Company:	MASTER LEADER INTERNATIONAL LTD				
Model No:	000786	IC Type:	SCTX2B	Size:	B
Date:	2008/04/24	Version:	08	Sheet:	1of 1
Drawn:	JunYi Liu	Check:		Approval:

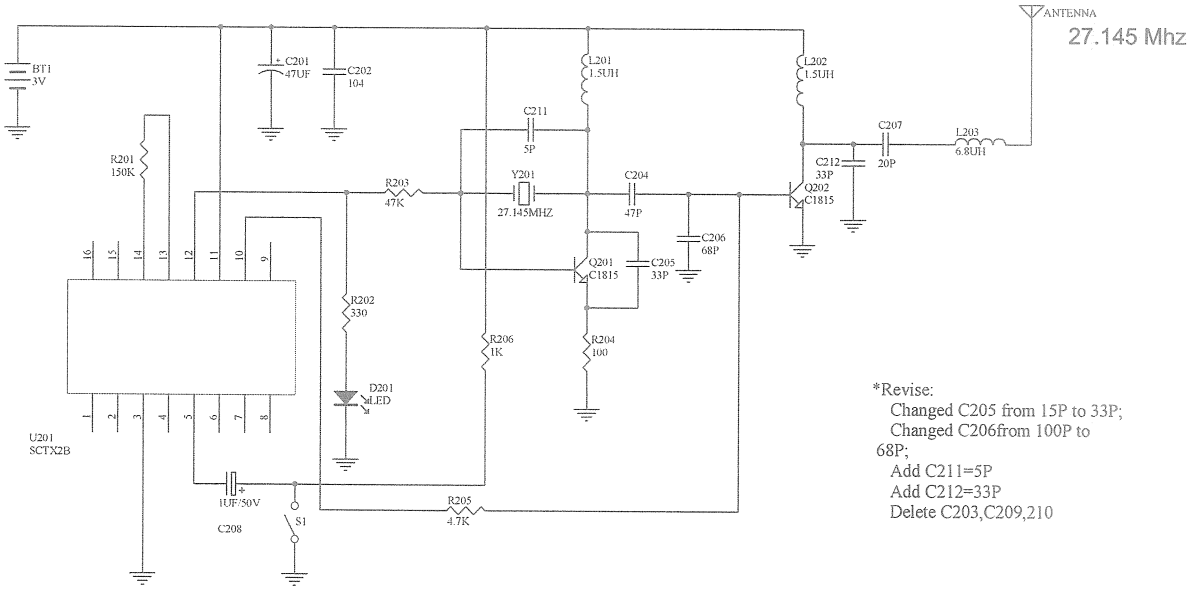
*Revise:
Changed C205 from 15P to 33P;
Changed C206from 100P to 68P;
Add C211=5P
Add C212=33P
Delete C203,C209,210
